MEMORANDUM

Your Reference: P/2025/0337

PROPOSAL:
Demolition of two double classroom buildings and replacement with a new 4 classroom block for infants/new nursery (phase 1). Construction of new 4 block classroom for juniors (phase 2)

LOCATION:
Ysgol I.D. Hoosen, Heol Caradoc, Rhosllanerchrugog, Wrexham

Figure 1: The pluvial flood risk present on the proposed development site in the wider context of flood risk in the area. The map is derived from the NRW Development Advice Map (DAM).

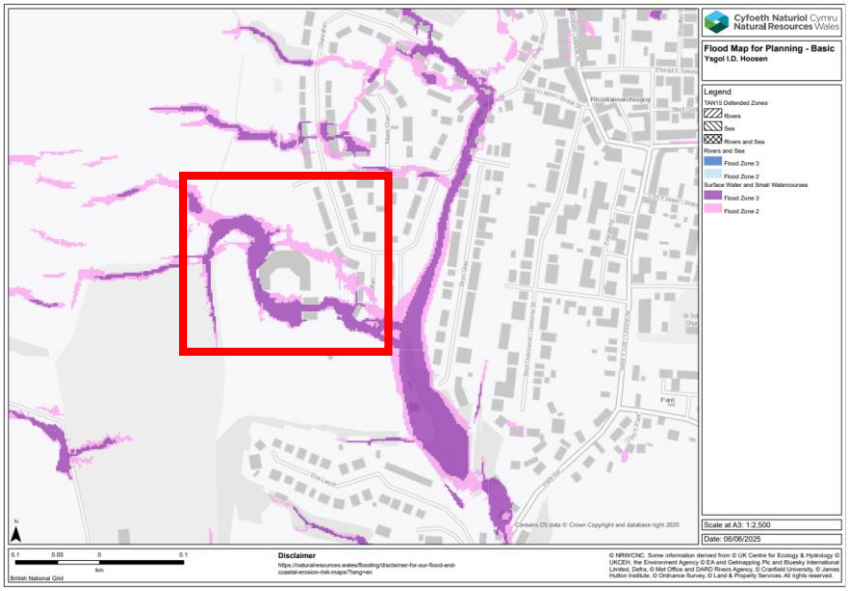
Flood Zone Status
The LLFA Teams notes that the proposed development sits in Flood Zone 3 for surface water, or pluvial, flooding. The extent of this flood zone area is shown in Figure 1. The development proposes an extension to an existing school site. The LLFA notes that this would be classed as highly vulnerable development under TAN 15 and allocation for such development, even as a part of redevelopment, should be avoided in this flood zone.

Figure 2: An illustration showing the normal vehicular route to Ysgol I.D. Hoosen and that taken when flooding prevents vehicular movements through Brook Street. The photographs illustrate flooding on both routes in the most recent flood event affecting the community on Wednesday 16th October 2024.

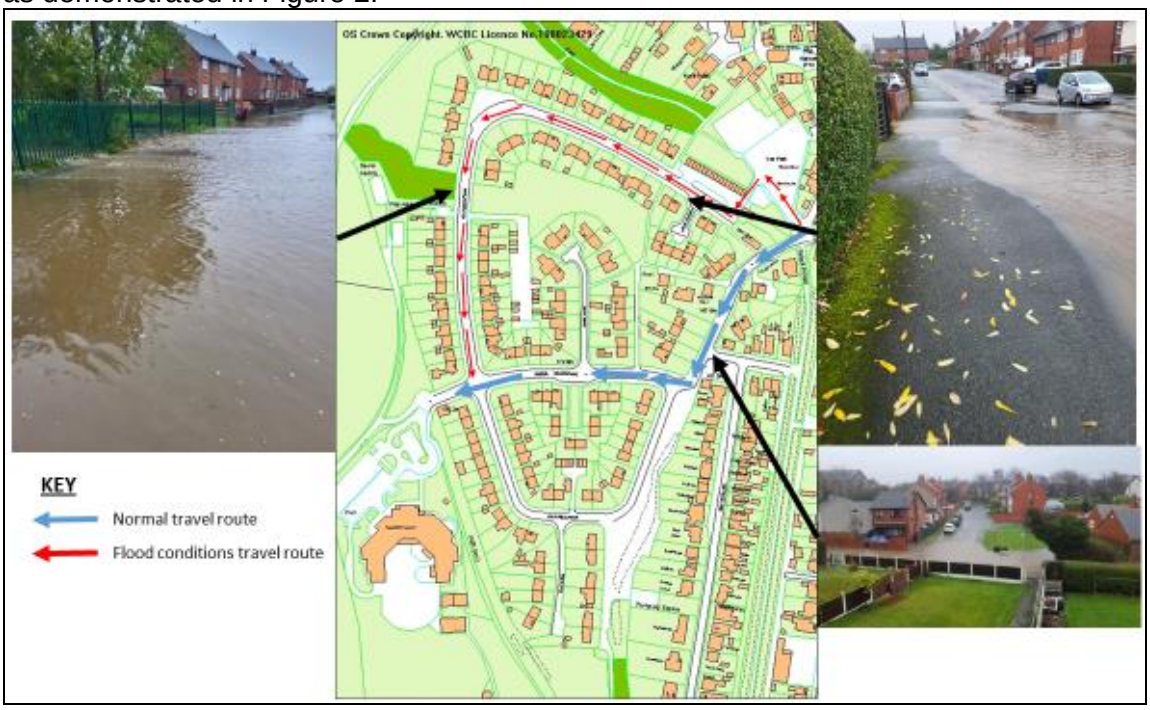
The LLFA would ask the LPA to continue to consider offsite flooding which affects access to the proposed development within its determination as this has not been considered in the Flood Consequence Assessment (FCA). During normal conditions, access to the proposed development is along Brook Street and up Heol Caradoc. However, Brook Street is prone to frequent flooding after heavy rainfall over periods of a few hours or thunderstorm events to a level where road closures are required. As such, an unofficial evacuation route via a car park off Bonc Wen is in place as demonstrated in Figure 2.

It is noted by the LLFA that this emergency access route to the school also suffers from flooding in more extreme rainfall events. Figure 2 shows images from the most flood event on 16th October 2024 which illustrates how impassable both routes towards the school can become during a high intensity rainfall event. It should be noted that pedestrian access during such flood events to the development would become difficult due to the flow velocities of the water from the overtopping of the Afon Goch tributary culvert on to Glanrafon. Pedestrian access to the development via Brook Street during such flood events is also not encouraged due to the depth of the flood water. The LLFA are aware that the flood scenarios in Figure 2 can cause combined sewerage systems to be overwhelmed and so the flood water is also likely to be contaminated.

In regards to the issues raised by this section, the LLFA would like to request that an emergency evacuation route is included in the Flood Consequence Assessment (FCA) given the Flood Zone classification of this development. We note that no flood warnings are available for this location so the LLFA feels that the triggers for preventing harm the users of the proposed development is quite key to the application and should form part of the application.

Figure 3: An overview of the offsite flood risk associated with the Afon Goch. The proposed development is located to the top left of the image.

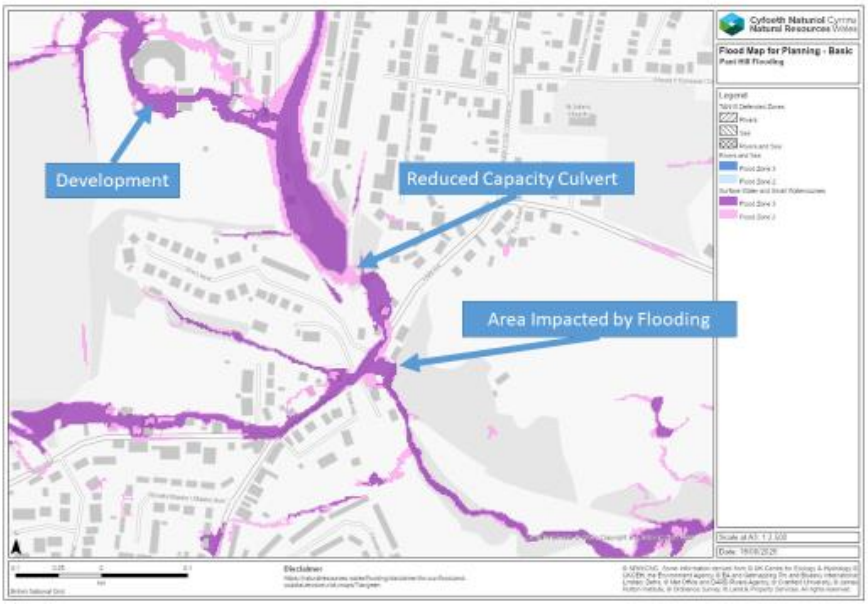
The SAB is satisfied that the development cannot achieve substantial water reuse. We are also satisfied that infiltration is not a viable method of surface water management on this development site due to the presence of made ground and the proximity of nearby coal workings. Therefore, the SAB accepts that the development proposes to discharge its surface water through an existing drainage system which discharges to the Afon Goch. However, it should be noted that this watercourse presents a significant downstream flood risk to properties and highway infrastructure on B5097 Pant Hill, Rhosllannerchrugog as shown in Figure 3. In part, this is due to a reduced capacity culvert located under the old railways line off Lower Mountain Road. The LLFA Team has evidence of this flooding in 2005, 2012, and 2016. Of these, both the 2005 and 2016 events led to internal flooding to properties.

In a situation where the receiving water is of such a flood risk, the SAB would usually suggest that the developer moves down the discharge priority hierarchy. However, all surface water sewers in the area currently discharge to the same water body and the combined sewerage system becomes overwhelmed in high rainfall events. Consequently, the SAB is not satisfied based on the pre-

application advice alone that this development can be suitably drained without causing additional flood risk.
